Enclosure 1

COLA will be revised as shown in this enclosure. These mark-ups are based on COLA Rev. 6 and replace those provided in RAI 03.07.01-29, Supplement 1 in their entirety.

3H.10 STP 3 & 4 Resolution of Issues with Subtraction Method of Analysis Identified by DNFSB

Figure 3H.6-34: Broadened FRS in E-W (X) Direction at the Mid-Level of Cooling Towers (Elevation 125.25 ft MSL)

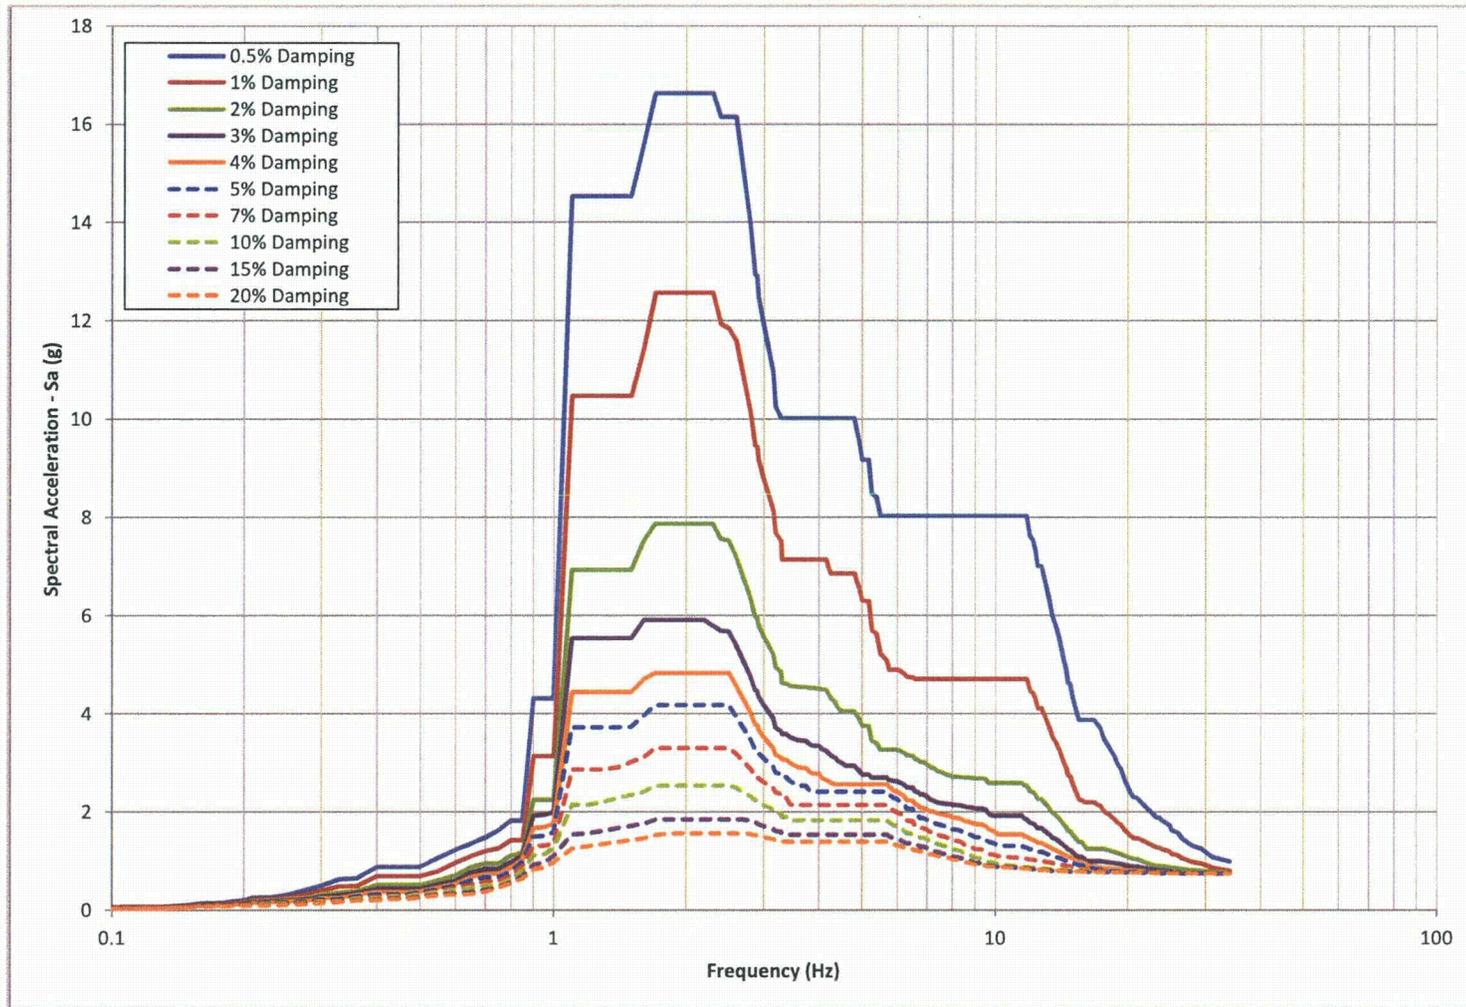
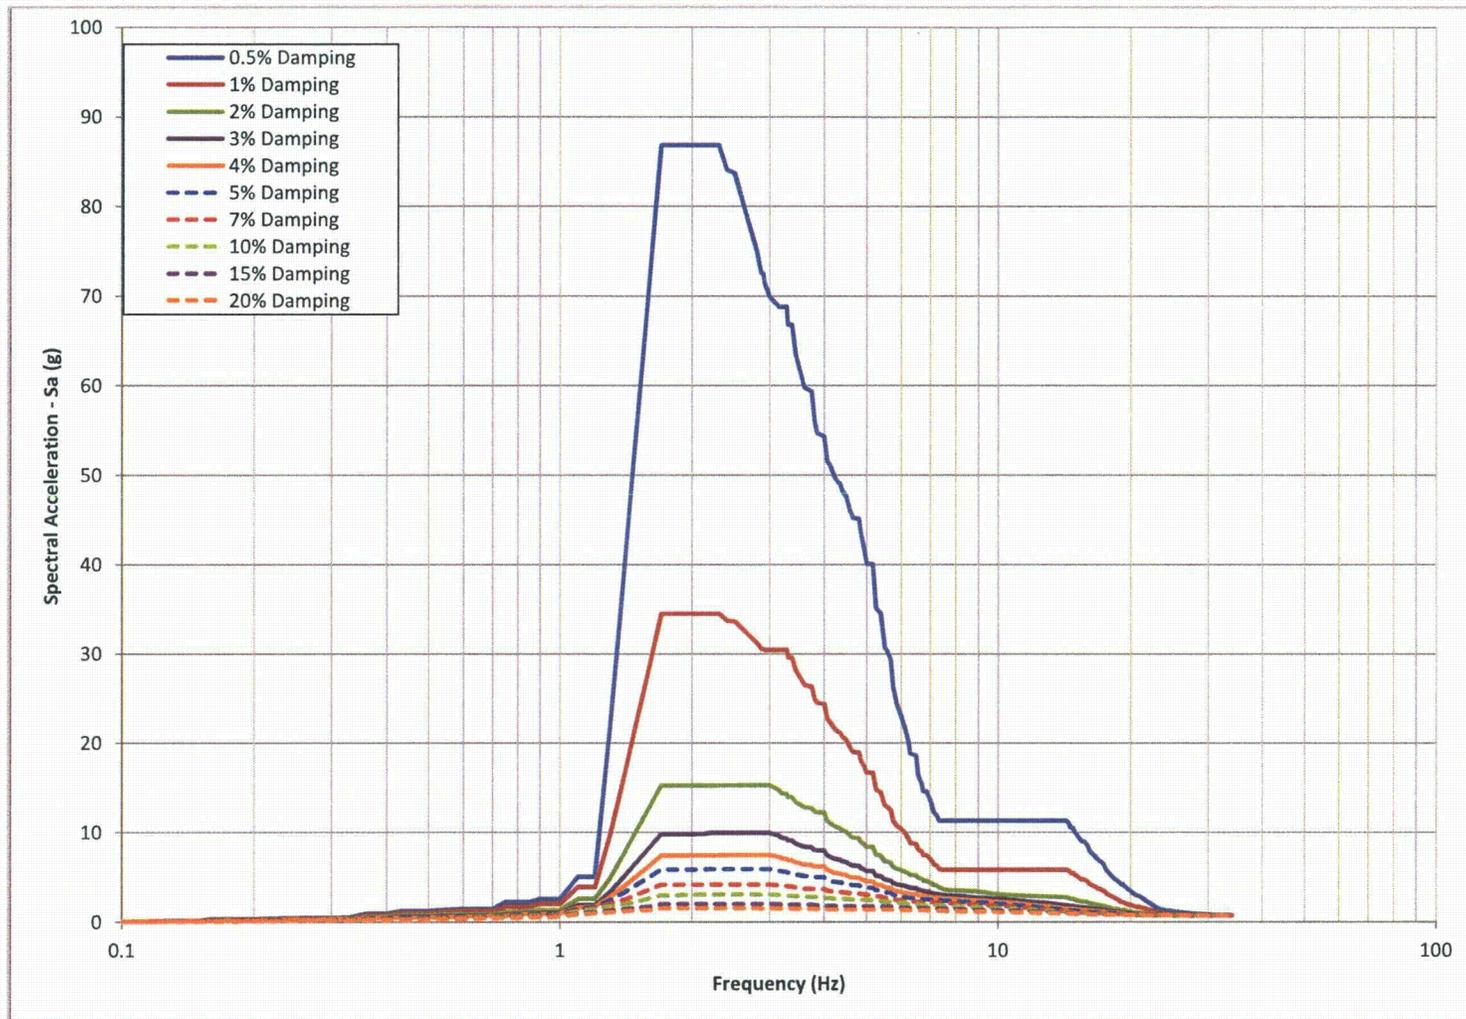
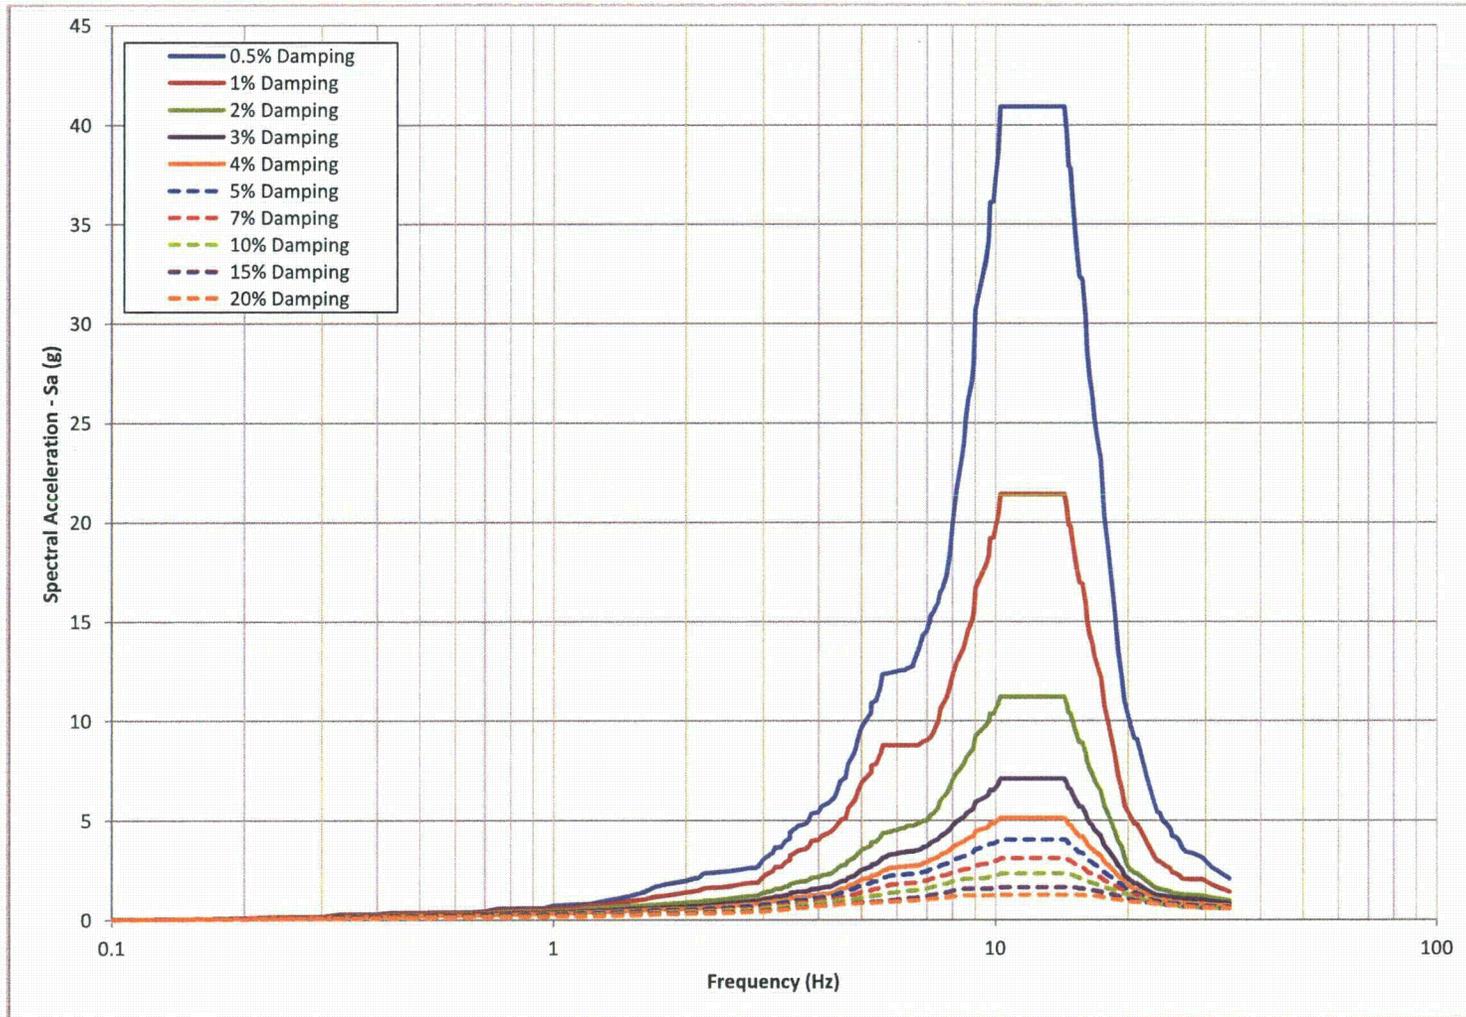
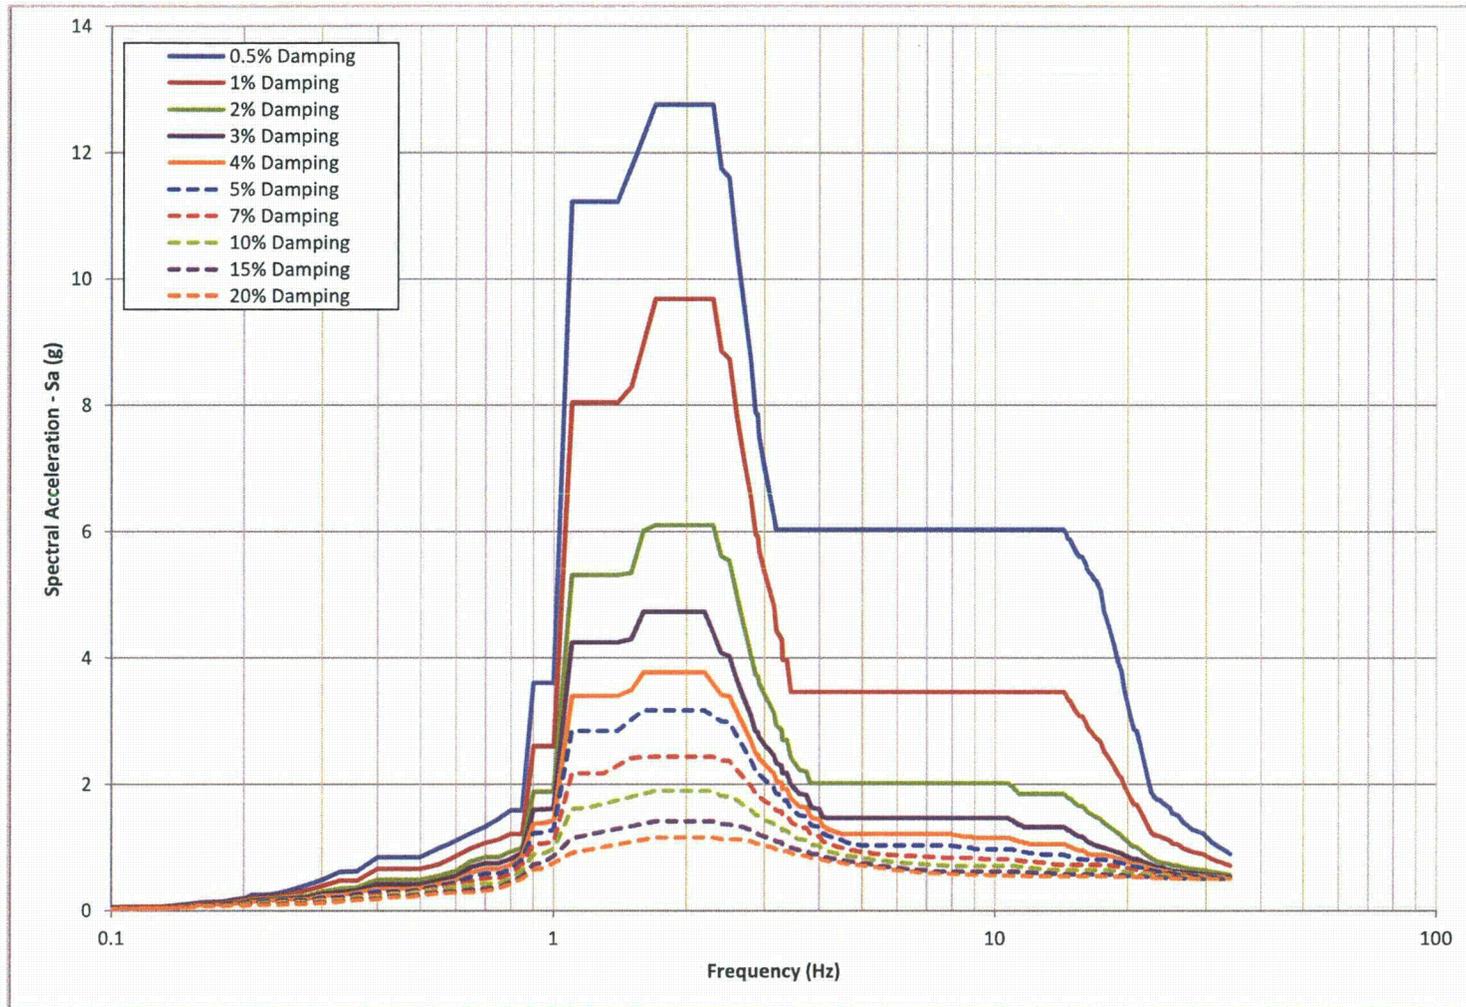
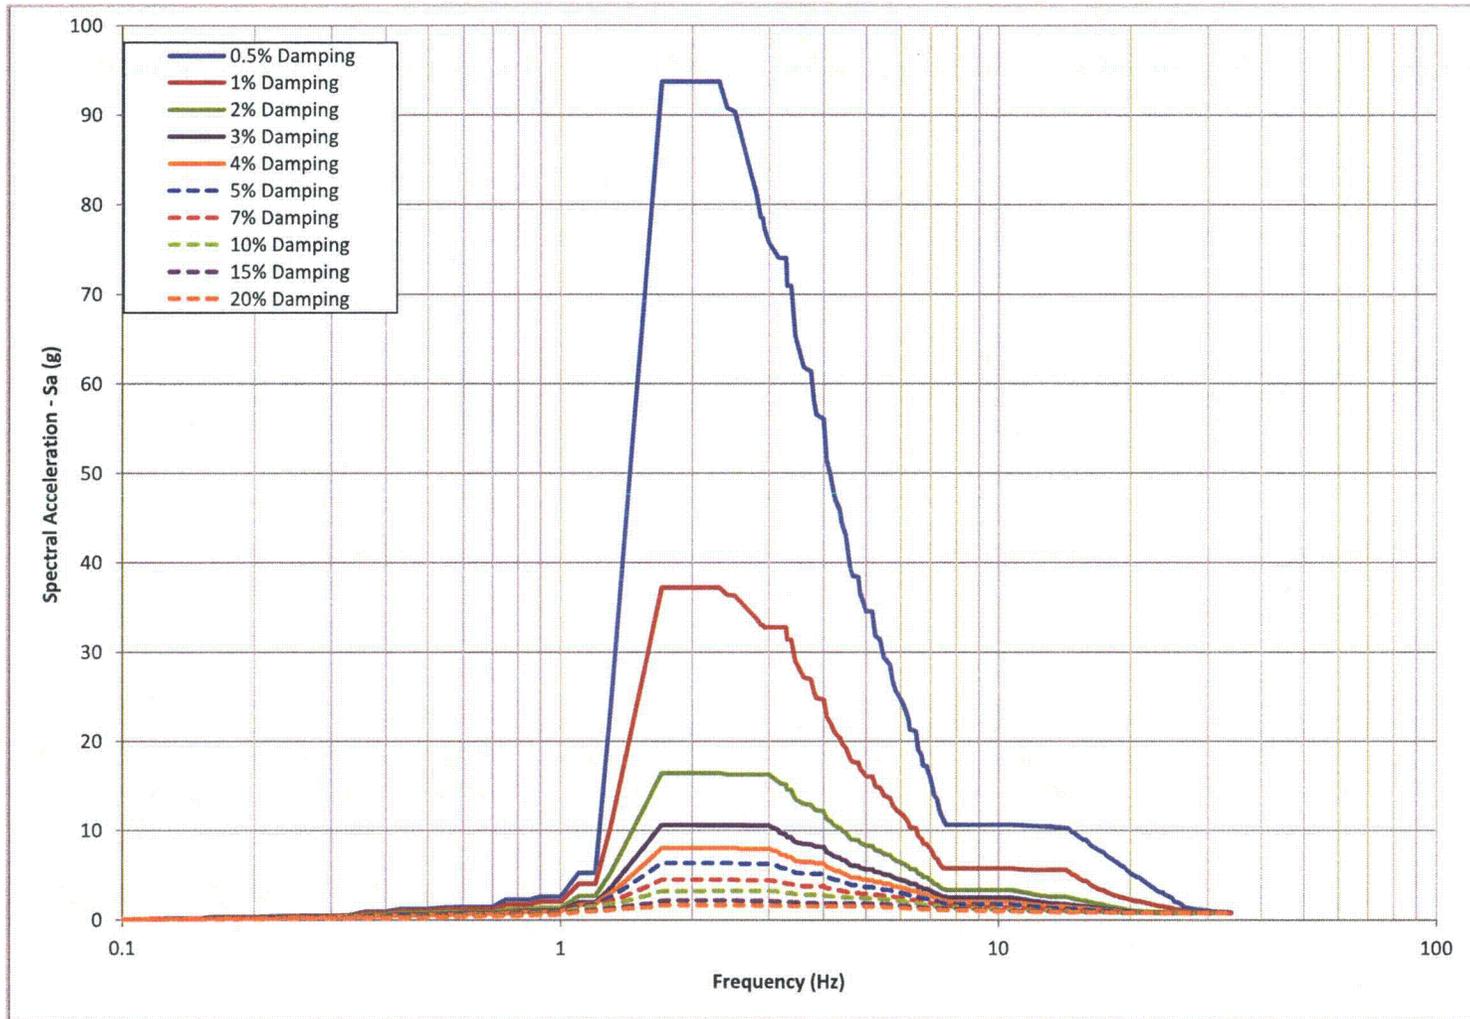
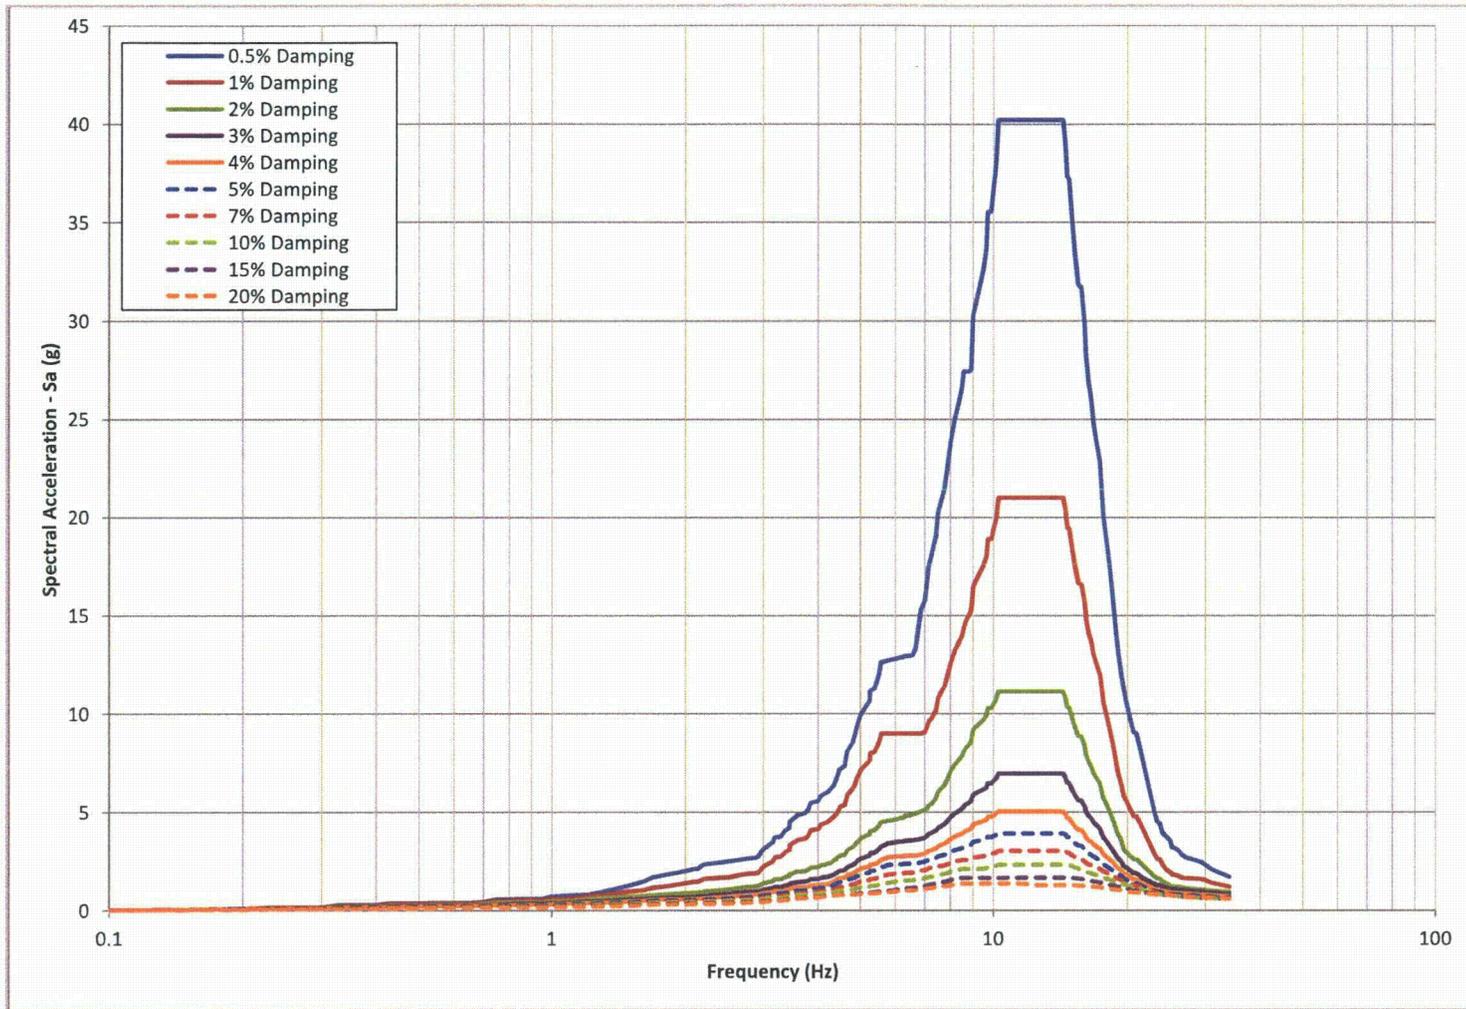
Based on the results of the above refined SSI analyses, and additional structural mesh sensitivity analyses, envelope modification factors were determined for increase of the following in-structure response spectra obtained from the SSI analyses described in Section 3H.6.5.2.4 and 3H.6.5.2.4.1. were modified by multiplying them with the modification factors shown in Table 3H.6-17. Then, the results of the full and empty basin analyses were enveloped.

- Vertical direction spectra at the center of the Pump House Roof
- Vertical direction spectra at the center of the Pump House Operating Floor
- Vertical direction spectra of the Cooling Tower Walls
- Out-of-plane horizontal spectra of the Basin Walls

In response to issues with the subtraction method of analysis identified by the Defense Nuclear Facilities Board (DNFSB) discussed in Section 3H.10, the SSI analysis for the upper bound in-situ soil case was repeated for both full and empty basin cases using the modified subtraction method of analysis. Also, in these analyses the groundwater table was changed to 6 ft below grade. Based on comparison of the resulting response spectra from these analyses to those from the subtraction method of analysis additional modification factors were determined for increase of in-structure response spectra from the subtraction method of analysis to account for the effect of using the modified subtraction method. The product of these modification factors and those described in Section 3H.6.5.2.4.2 as shown in Table 3H.6-17 were used to increase the in-structure response spectra described in Sections 3H.6.5.2.4 and 3H.6.5.2.4.1. Then, the results of the full and empty basin analyses were enveloped.

The final in-structure response spectra are shown in Figures 3H.6-16 through 3H.6-39.

The final in-structure response spectra are shown in Figures 3H.6-16 through 3H.6-39.
